FED. ROAD DIST. NO.	STATE	PROJ. NO.	FISCAL YEAR	SHEET NO.	TOTAL SHEETS
HAWAII	HAW.	HWY-0-08-14	2016	ADD. 12	88

STATE OF HAWAII DEPARTMENT OF TRANSPORTATION HIGHWAYS DIVISION	
ROADWAY PLAN	
COMMERCIAL DRIVER'S LICENSE AND MOTORCYCLE LICENSE TESTING FACILITY EXAMINATION SITE AND OFFICE RENOVATION	
Beneath Interstate Route H-1 Pearl City Viaduct Project No. HWY-0-08-14	
Scale: 1"=40'	Date: May 2016
SHEET No. 1 OF 1 SHEETS

C.O. ADD. 12

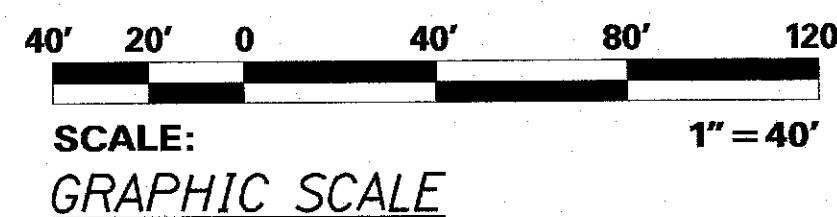
Added Guardrail

Added Civil Engineering Branch and Traffic Review Branch signature.
Added callout for centerline striping and stop bar work.
Revised sliding gate note.
Added label for Hugh St. in State r/w.
